**STAFF REPORT TO
THE BOARD OF ARCHITECTURAL REVIEW
PREPARED July 17, 2013**

FILE NUMBER: PW13-018, E13-006, L13-018

APPLICANT: Jared Taylor, Golden Property Development

REQUEST: Design Review approval for a new 8,451 square foot building including a 1,365 square foot enclosed patio to be built on the pre-existing foundation. Site improvements, landscaping and parking will not change.

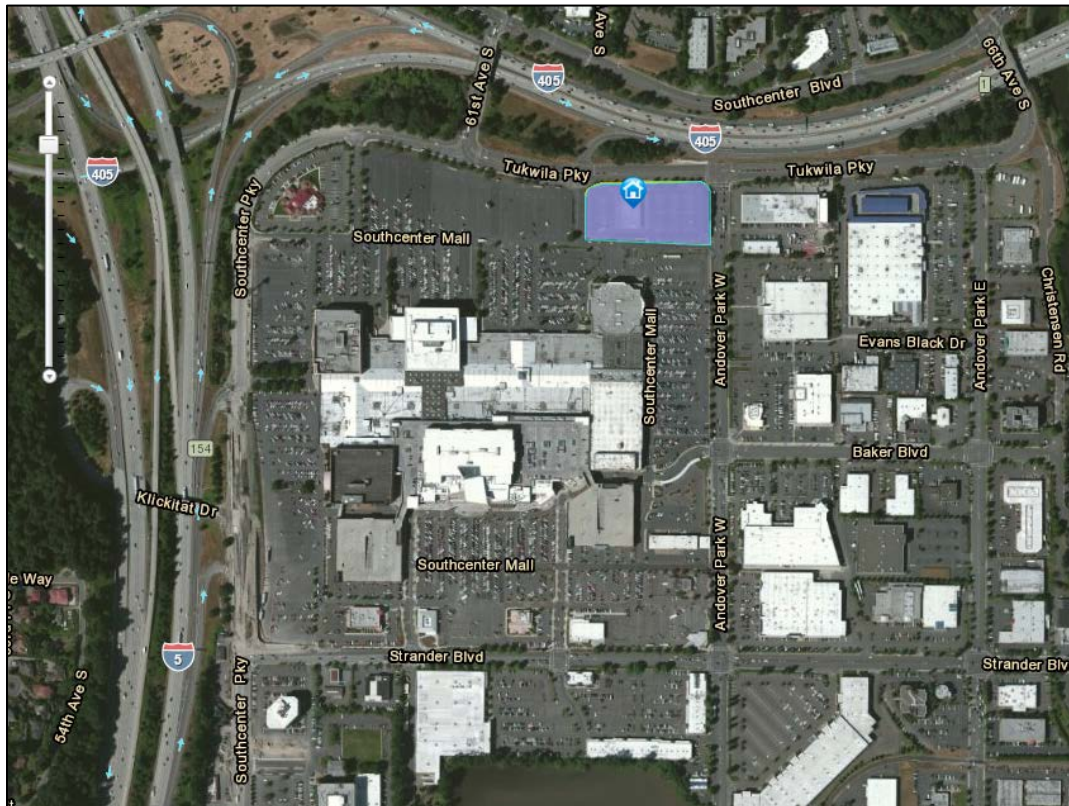
This photo depicts the *Stadia* model Buffalo Wild Wings under construction. The building proposed for Tukwila is similar but not identical. See Attachment C.
